**Re AUSTRALIAN MUSEUM – ALTERATIONS & ADDITIONS  
SSD 9452  
REVISED DESIGN STATEMENT**

In response to the feedback received from the Government Architect on the 18<sup>th</sup> December 2018 regarding SSD 9452 for the Australian Museum – Alterations & Additions the design team has completed a review of the feedback with the Museum to address the key points raised. The key changes following the SSD submission on the 11<sup>th</sup> August 2018 are detailed below. Please read these in conjunction with the updated drawings, reports and submissions table.

# LEVEL 4

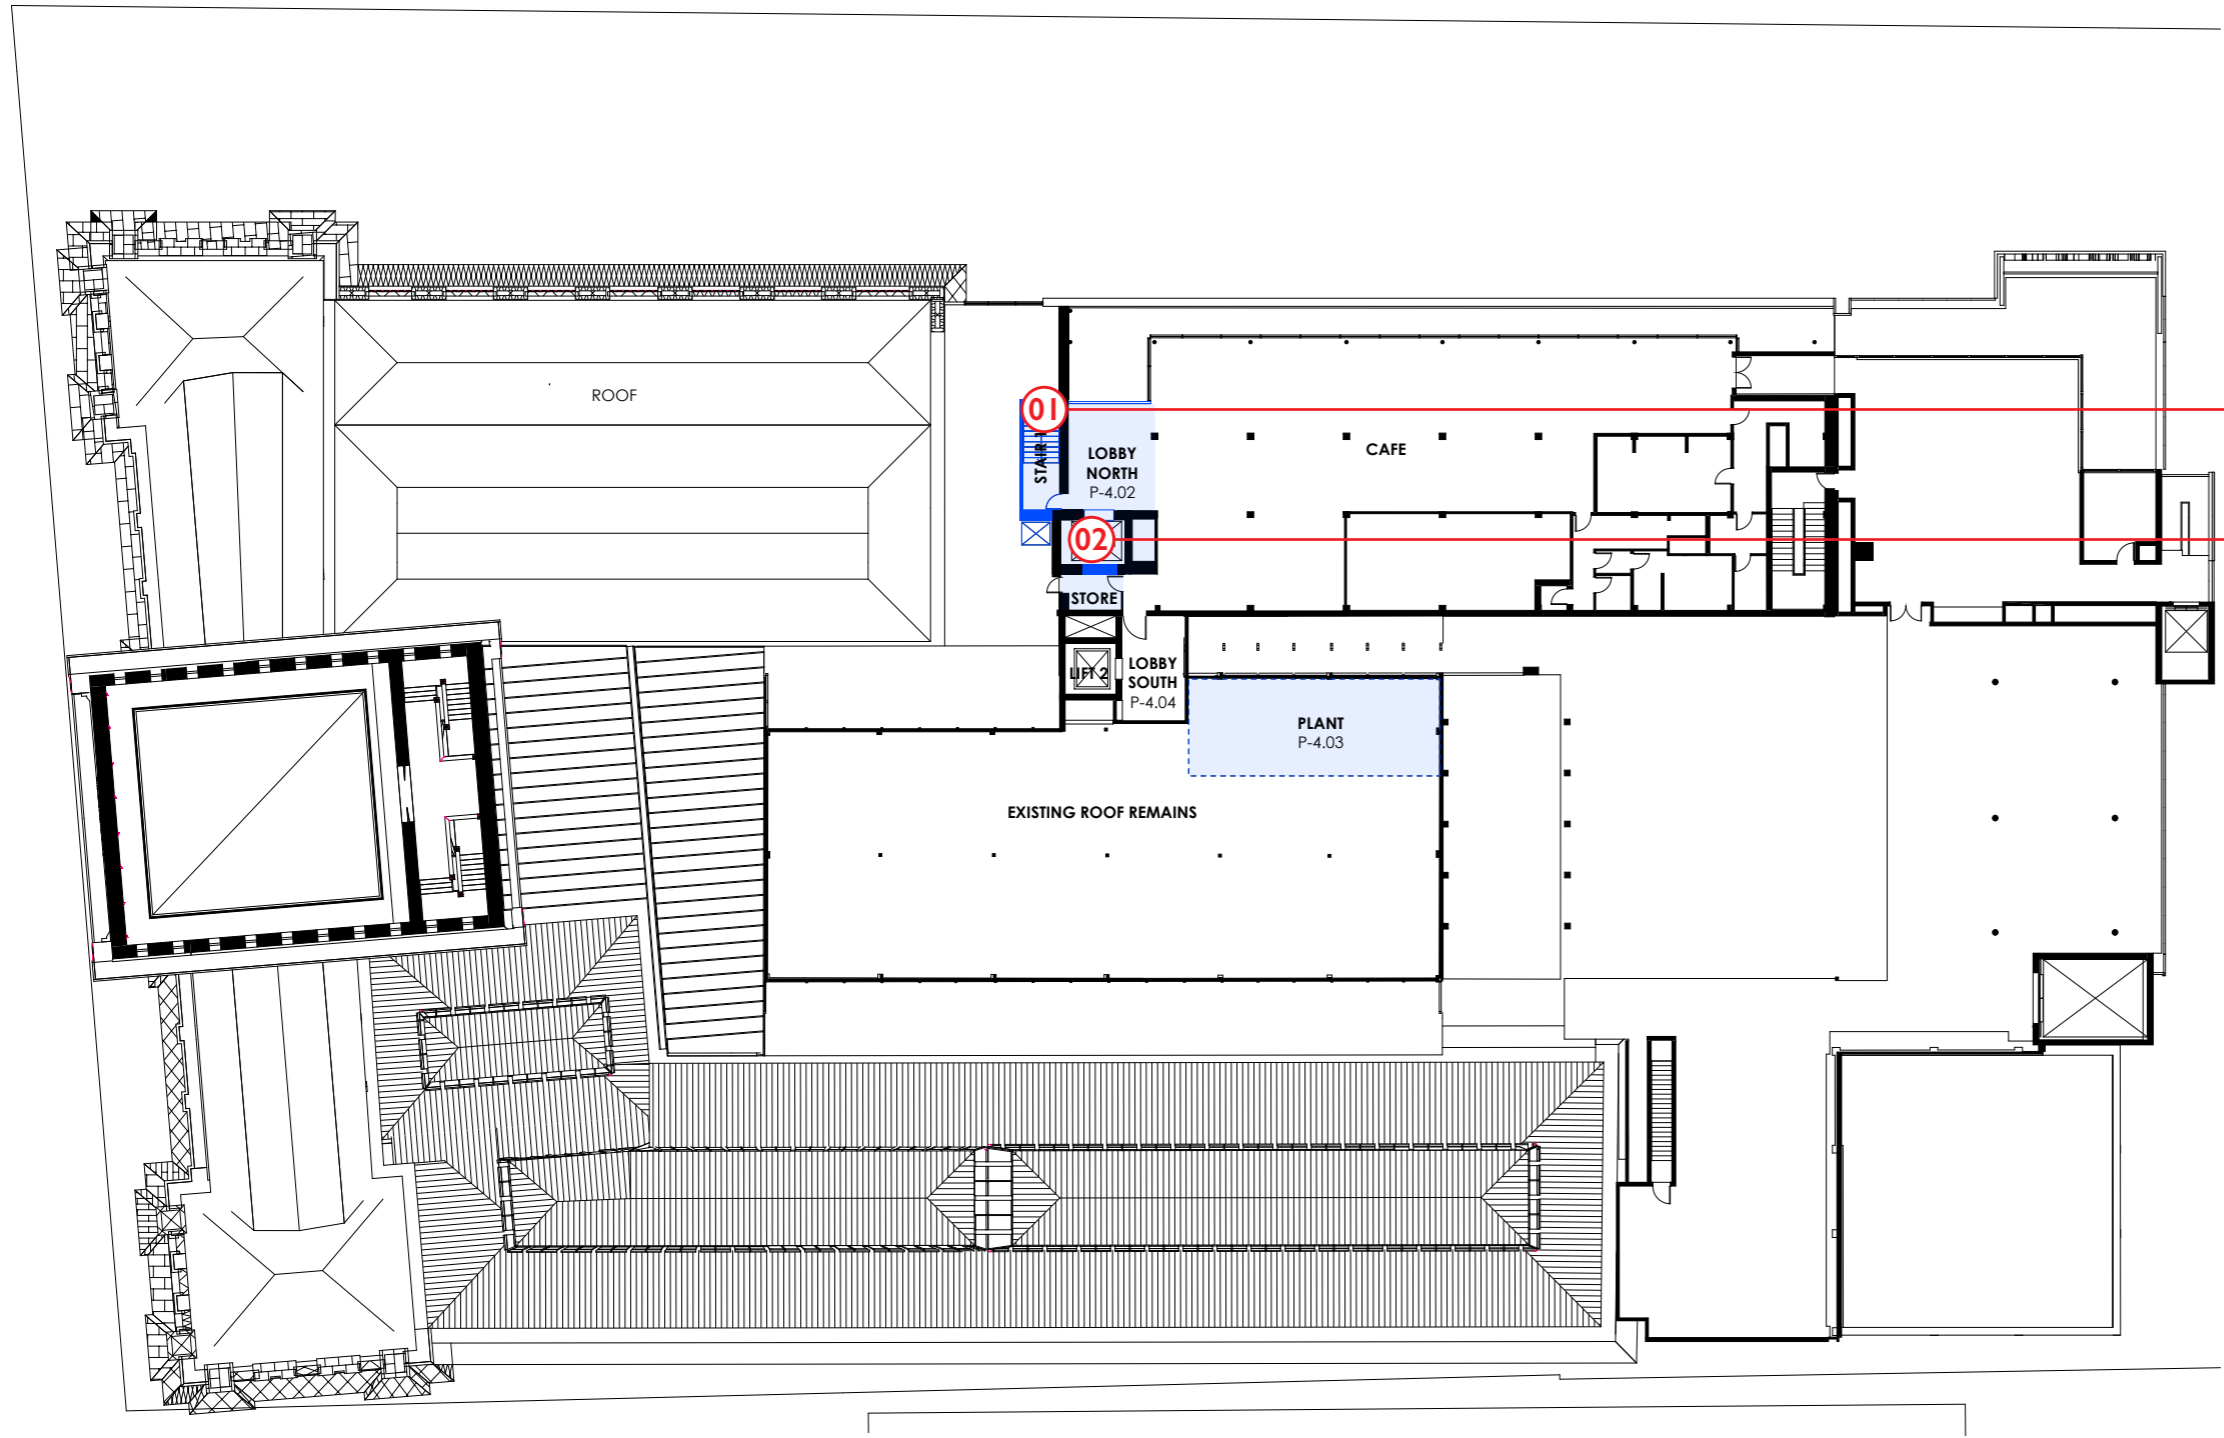
NEW STAIR DISCHARGES TO LEVEL 4 CAFE

LIFT ALTERED TO OPEN TO NORTH - VIEWS OUT TO THE CITY
